January 27, 2021

Re: HDD 290 Emergency Permit Application Status and Response to Comments

PROJECT NAME: Sunoco Pipeline LP Mariner East 2 Pennsylvania Pipeline - Spread 6 **PROJECT NO.:** 096303002

SUBJECT: S3-0290 Milford/Little Conestoga Road Grouting Procedures

Attachment E

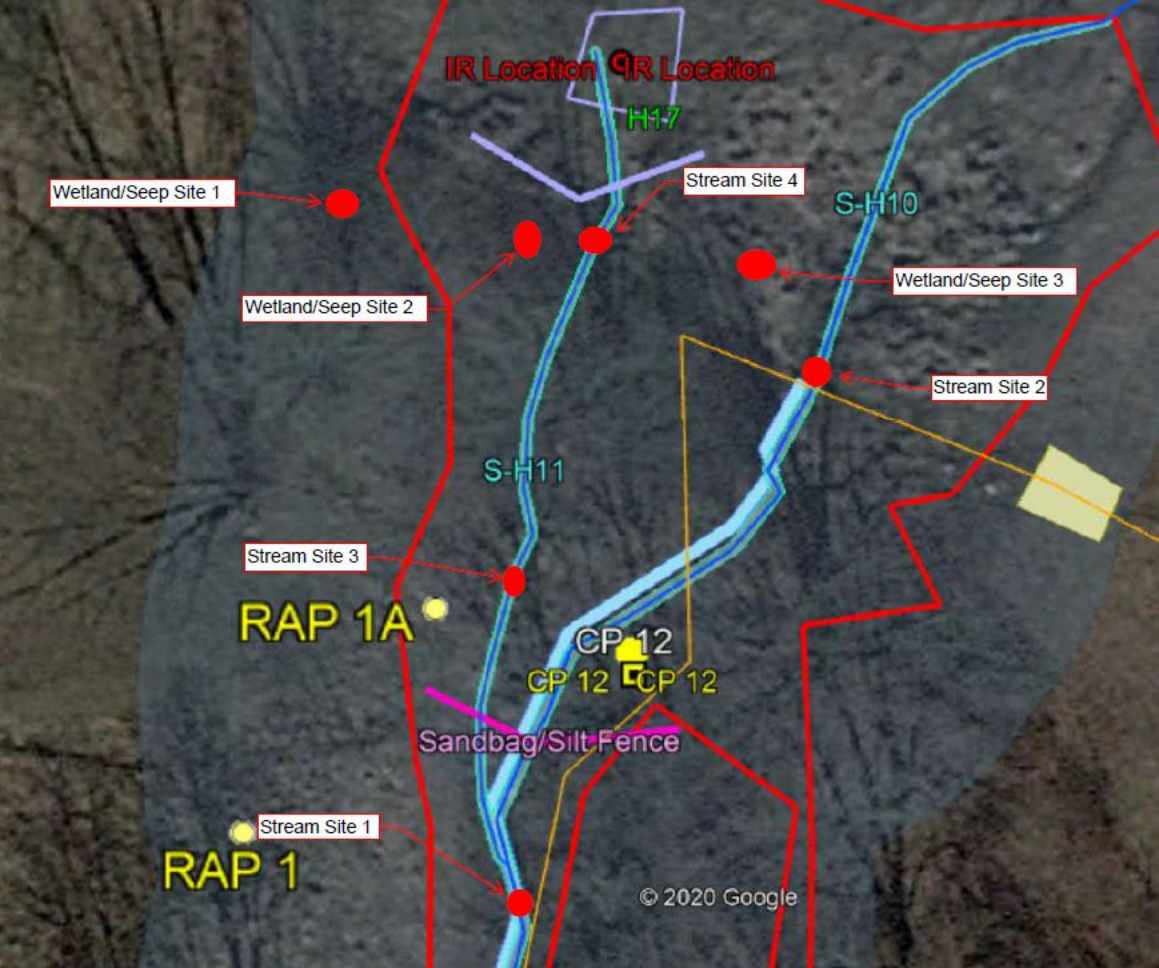
5. *Provide discussion and monitoring plan that addresses water quality and pH concerns for adjacent wells, streams, wetlands, seeps.*

On the fifth and final comment, the Department requests a monitoring plan regarding water quality and pH concerns for adjacent residential wells, streams, and seeps. SPLP has developed a proposed well test plan to monitor water quality and pH for those well owners willing to allow testing. A copy of this testing plan is provided as **Attachment “D.”** SPLP is in the process of contacting landowners to discuss the proposed plan, which addresses both pH and water quality, and this plan will be updated/finalized. Testing, if allowed by the landowners, will begin the week of January 25, 2021.

For the streams and seeps, SPLP has and will continue to monitor water quality, including pH, once a week at the monitoring points listed in the Impact and Assessment and Restoration Plans previously submitted to the Department. This monitoring will continue at the downstream points of the existing containment structure on a daily basis when the borehole grouting activity has started. SPLP will also sample at an additional 4 monitoring points within the stream and an additional 3 monitoring points wetland/seep (as shown on the map provided as **Attachment “E”**), which will be tested for pH once per week beginning the week of January 25, 2020, and then daily during the grouting activity.

The stream (SS) and wetland/seep (WL/S) sample points are depicted on **Attachment D**, and described as follows:

- SS-1: located on S-H10 downstream of all other new points but upstream of next closest monitoring point (MP6) that was established in August 2020
- SS-2: located on S-H10 along reach upgradient of S-H11 confluence
- SS-3: located on S-H11 just upgradient of confluence with S-H10
- SS-4: located on S-H11 upstream of other seep influences and immediately downstream of subsidence containment area
- WL/S-1: located primarily in wetland area that does not contain obvious surface water
- WL/S-2: located in wetland/seep area that has a surficial drainage pattern connecting to S-H11
- WL/S-3: located in wetland/seep area, variable location characteristic options available (surface water or no surface water)

The SS points would be sampled in flowing surface water that may or may not freeze at during the winter season with sufficiently cold temperatures, but to date they have not yet frozen. The WL/S points would be sampled via shallow piezometers that would be installed to a depth of approximately 2 feet below grade (similar to A54/A55 locations). It is likely any seep/surface water at these locations would freeze at some point during this winter season, which is an additional reason to install the piezometers. SPLP will record pH, SC, and temperature at each of these seven additional monitoring locations.
